SERVICE BULLETIN NUMBER 127

MODIFICATION M228

TITLE	CKT exhaust
CLASSIFICATION	The CAA have classified this bulletin as Mandatory.
COMPLIANCE	All aircraft, Inspection before further flight. At or before the next permit renewal, fit modification M228 or modified exhaust (exhaust serial number 10940809 onwards)
APPLICABILITY	All Quik, GT450 & QuikR fitted with CKT stainless steel twin exhausts. The CKT exhaust serial number is stamped on one end cover plate.

Fig 1. Crack location all round weld outer edge

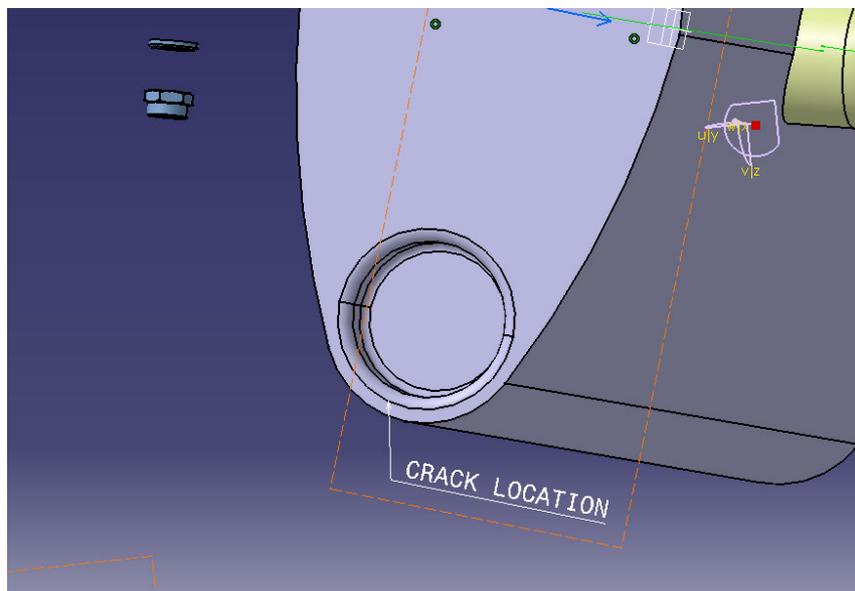
The CKT exhaust silencer has separate front and rear perforated baffle tubes which are welded to the front and rear end cap flanges and plugged with a cap. A fatigue failure of a pair of exhausts serial no. 7811107 has occurred at 125 hours, around the flange edge on the rear end cap, at the weld edge (see fig 1). The baffle tube came free and was ejected from the silencer and hit the propeller. Fortunately this happened at low power on approach, propeller damage was localised and the baffle tube missed the sail; under high power the consequences could be very serious.

Before further flight, using good light and a magnifying glass, closely inspect the area around all 4 silencer end caps for cracks, particularly on the weld edges (see fig 1). If cracks are noted, contact P&M Aviation, if possible by email attaching pictures of the damage, hours run, aircraft and exhaust serial numbers. The aircraft must not be flown with cracks in this area.

Fig 2. Movement of inner baffle plate.

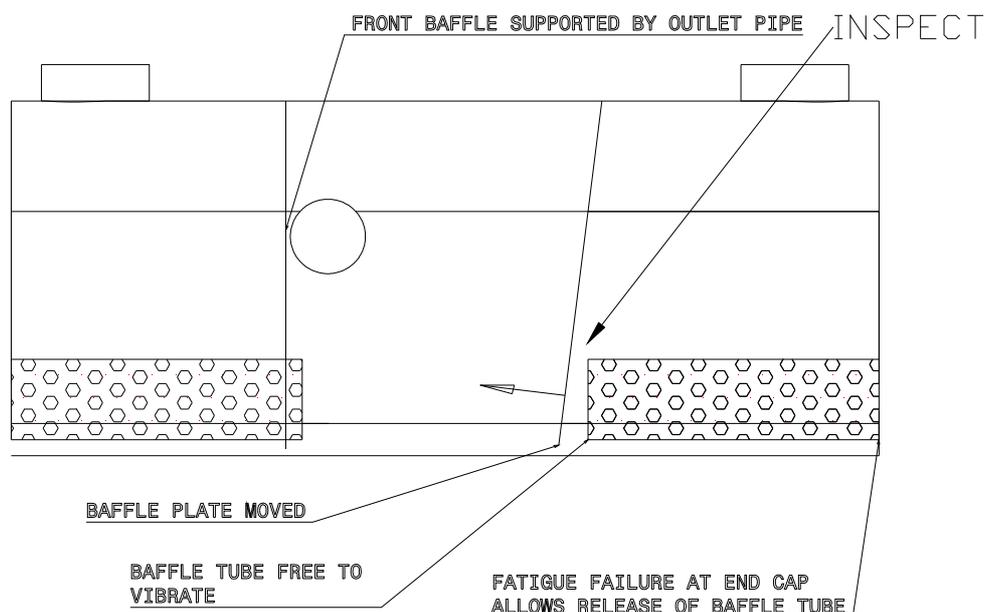
See fig. 2. Through the exhaust header pipe holes, using a torch and mirror, inspect the welded connection between the internal baffle plate and the end of the perforated baffle tube. Try pushing the bottom of the internal baffle plate inwards. If the baffle plate has moved inwards towards the centre of the exhaust and the baffle tube has disengaged from the baffle plate, ***the exhaust must be replaced***. Disengagement is more likely on the rear internal baffle, as the front internal baffle is supported by the outlet pipe.

Fig 3 Exhaust Keeper modification M228

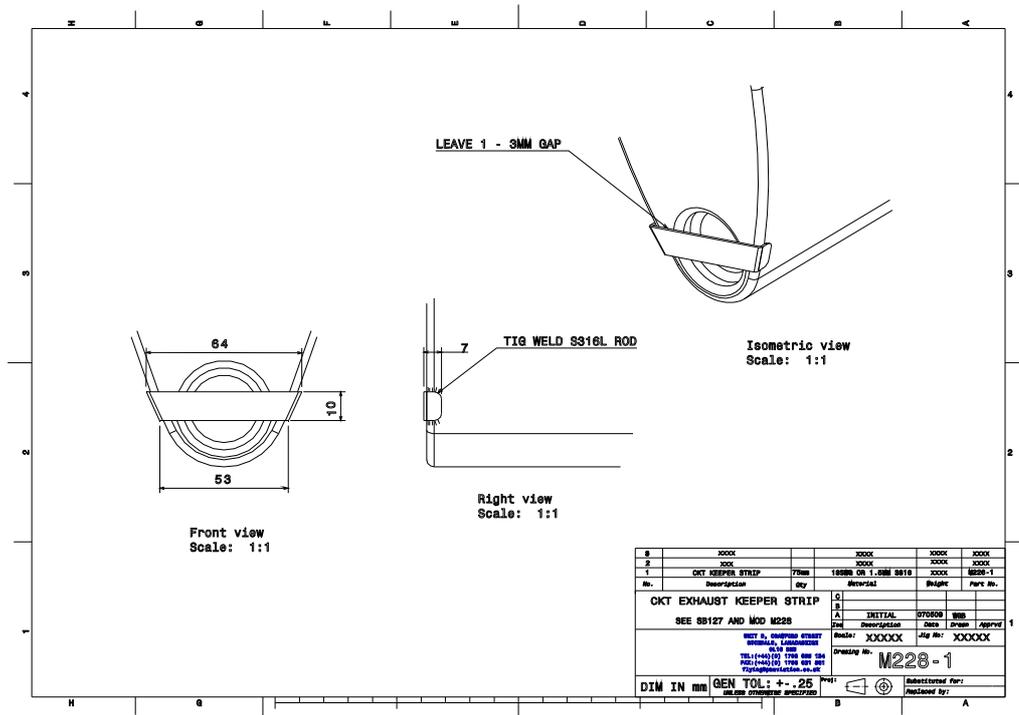
If the inner ends of the baffle tubes and internal baffles are secure, modification M228 can be carried out (see fig. 3). It provides a backup retainer if the baffle should become loose. Thoroughly clean the area. Do not use any dissimilar wire brush metals and do not mark with graphite or carbon pencils. Weld repair any cracks found using a stainless steel 316L welding rod and TIG process. Fit a 10mm wide x 18swg (1.22mm) or 1.5mm S316 strip with 7mm bent edges as shown, weld to the silencer ONLY at the corners, over the existing corner weld. The repair/modification must be carried out by a welder qualified for thin (0.9mm) stainless steel. FAA publication AC43-13-1B is a useful guide to procedures.

The problem has been solved by welding on back-keeper plates (modification M228), or by fitting new modified exhausts which have smooth end caps with no baffle tube features.
